ARKANSAS NUCLEAR ONE, UNIT 1 (ANO-1)  
STATION BLACKOUT SAFETY EVALUATION REPORT

TECHNICAL EVALUATION REPORT  
ARKANSAS NUCLEAR ONE, UNIT 1  
STATION BLACKOUT EVALUATION

TAC No. 68508

## Simplified Single Line Diagram for Station Blackout

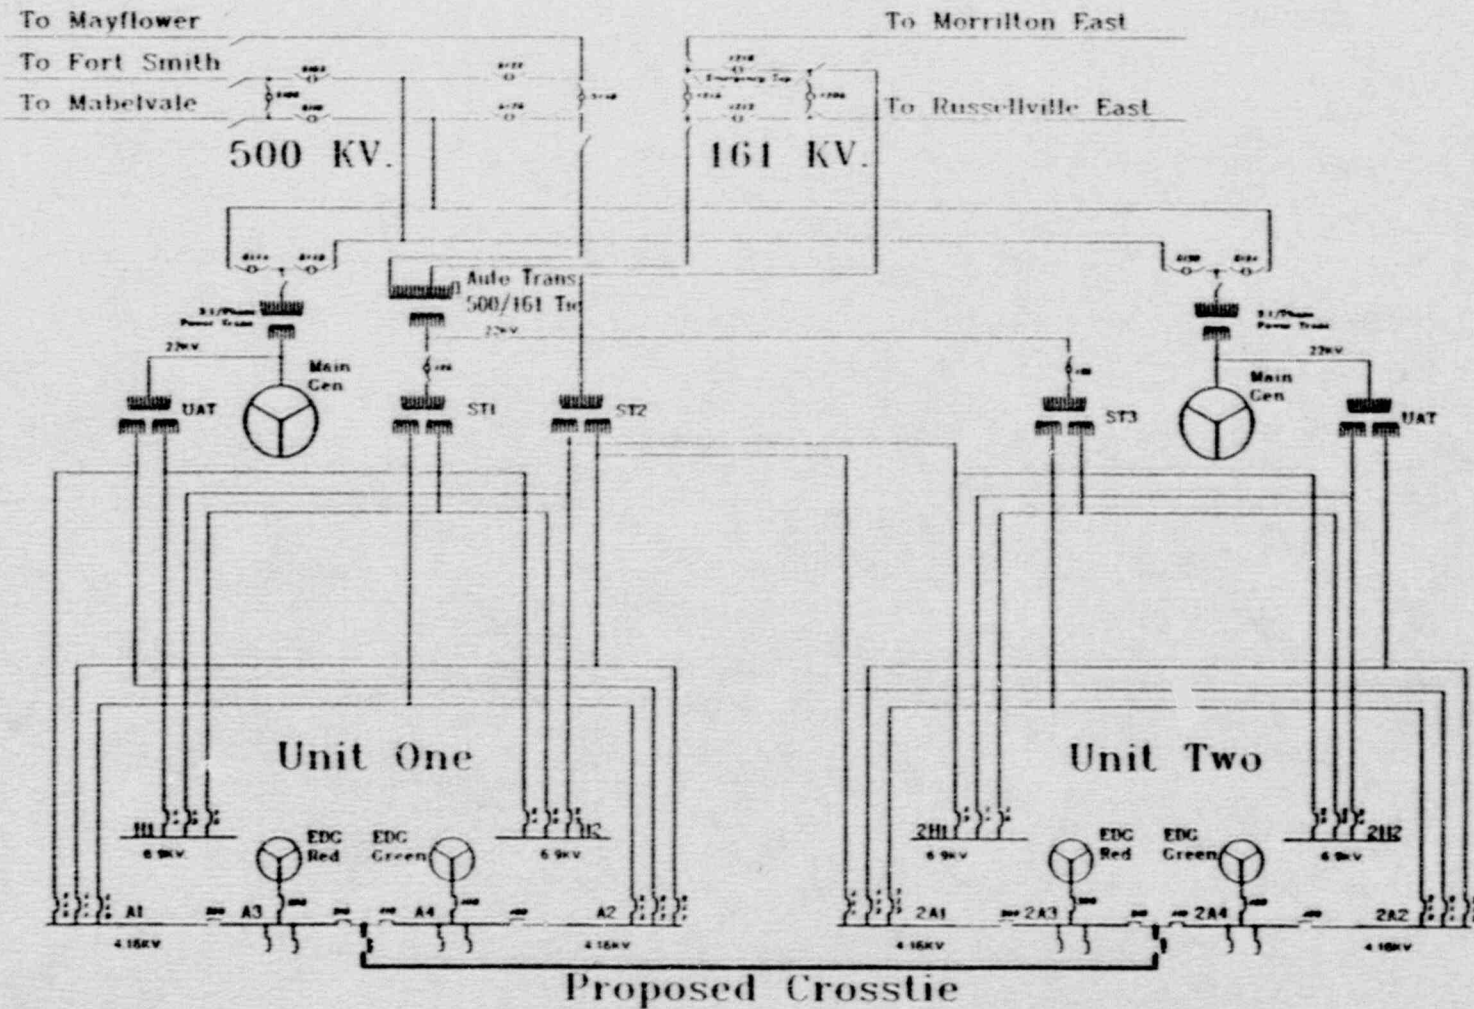
The licensee's proposed AAC power source configuration (Figure 1) conforms to a variation of an acceptable configuration provided in NUMARC 87-00 Supplemental Questions/Answers under Question C.1 (10). The AAC power source, one of the site EDGs, meets all the required criteria in Appendix B of NUMARC 87-00 except for the following cases:

The proposed cross-tie modification (see Figure 1) is consistent with an acceptable configuration provided in Appendix C to NUMARC 87-00, Supplemental Questions/Answer: Figure B of Sample AAC Configurations. This modification allows the licensee to power one of the emergency buses

The licensee's intended load shedding of the non-black-out (NBO) unit is not in conformance with the requirements of the SBO rule and the guidelines provided in RG 1.155, NUMARC 87-00 Supplemental Questions/Answers, and References 16, 17, and 18. The load shedding scheme will result in the degradation of LOOP safe shutdown capability of the NBO unit. This excess capacity made available by load shedding could not be credited as an AAC source for the blacked out unit (see the discussion under the AAC power source in Section 3.2). Therefore, the AAC power source does not have sufficient capacity to power the selected safe shutdown equipment in the blacked out unit.

Recommendation: The licensee should undertake further measures such as providing a separate AAC power source or a coping analysis which shows that the plant can cope with and recover from an SBO for the required duration independent of AC power.

Recommendation: The licensee's proposed AAC for ANO-1 does not conform to the SBO rule requirements, and therefore the licensee should consider the addition of an independent AAC source. The licensee should provide a full description including the nature and objectives of the required modifications to meet the SBO rule and a proposed schedule for implementation.
